**Public Input on General Electric's
Treatability Studies Summary Report for Reach 5A
dated February 27, 2026**

February 2026 – April 2026

Technical Assistance Services *for* Communities GE-Pittsfield/Housatonic River Site Comments on Treatability Studies Summary Report for Reach 5A February 2026

**Technical Assistance Services for Communities (TASC)
Comments on Treatability Studies Summary Report for Reach 5A
February 2026**

Figure 1: Sediment Sample Locations along Reach 5A

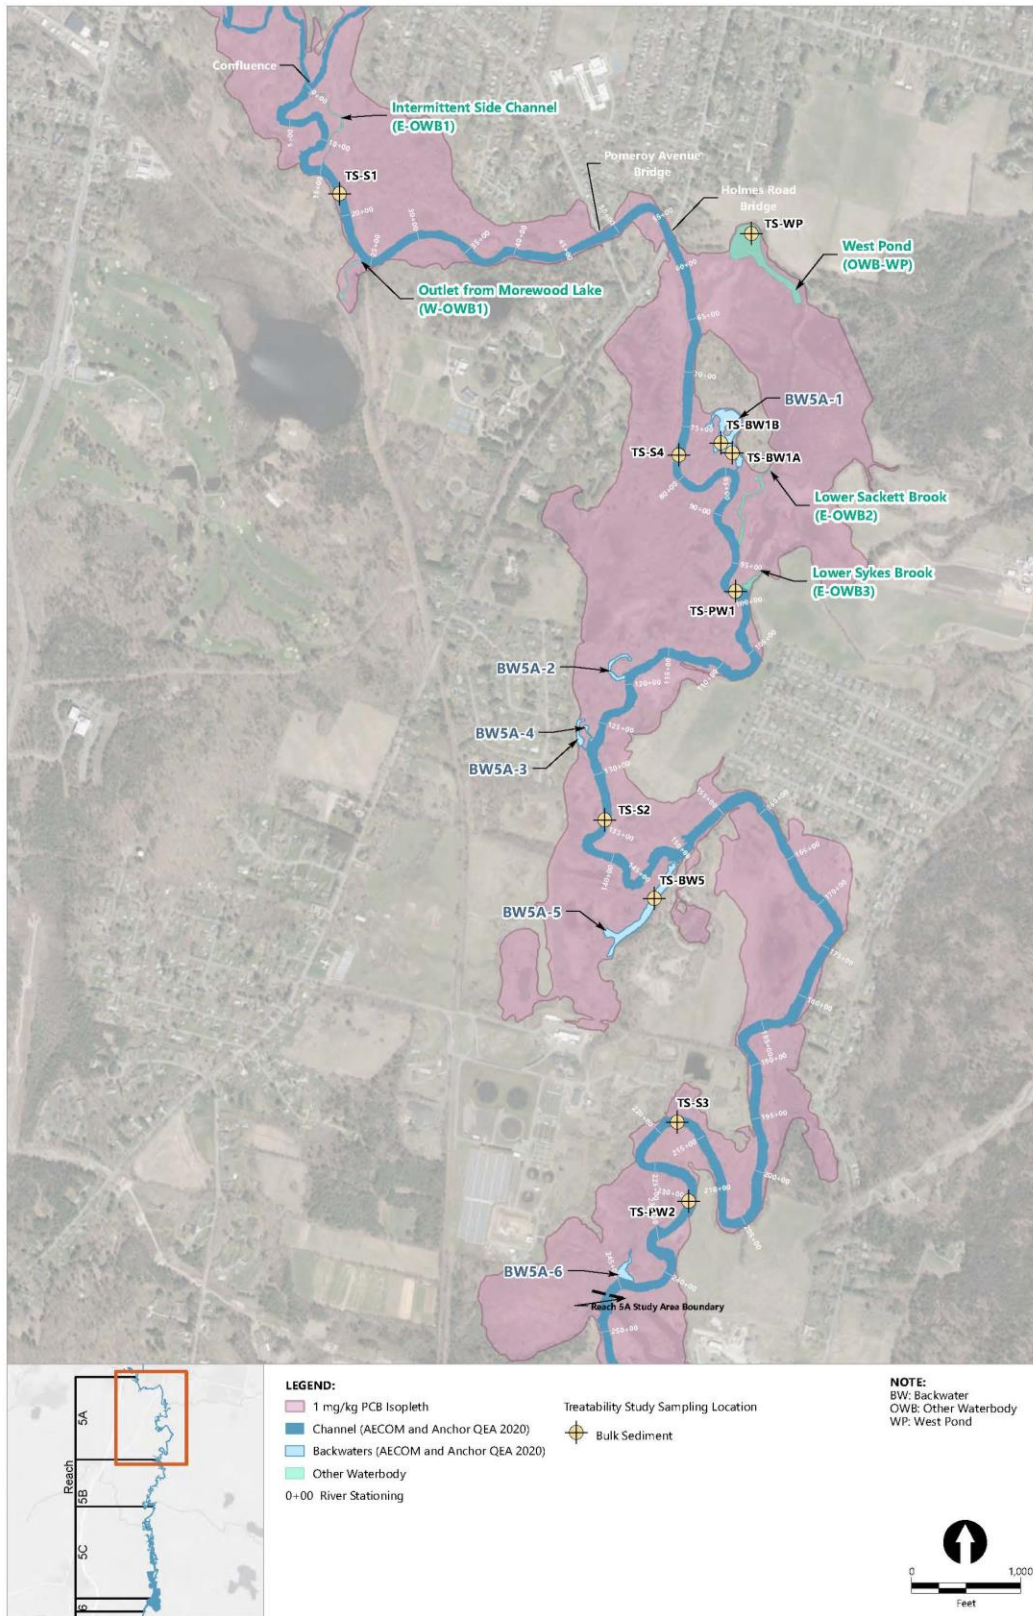
The Sediment Dewatering Treatability Testing section addresses objectives 1 and 2: effective dewatering methods, and identifying reasonable expectations for PCB concentrations in sediment removal work. Sediment and surface water samples gathered from six locations along Reach 5A were tested (Figure 1). Dewatering methods tested included samples of sediment (as removed from the environment) and samples of sediment amended using different concentrations of Type II Portland Cement placed on filters to monitor drainage via gravity. Both options were also tested using shake or vibration testing with the goal of materials in the sediment separating into layers by particle size (stratification) and separation of excess liquid from solids. For all combinations, the liquid resulting from each sample would still pass through the filter (filtrate). Contaminant concentrations in filtrate will be used to design the treatment system for liquid that is separated and filtered from sediment solids.
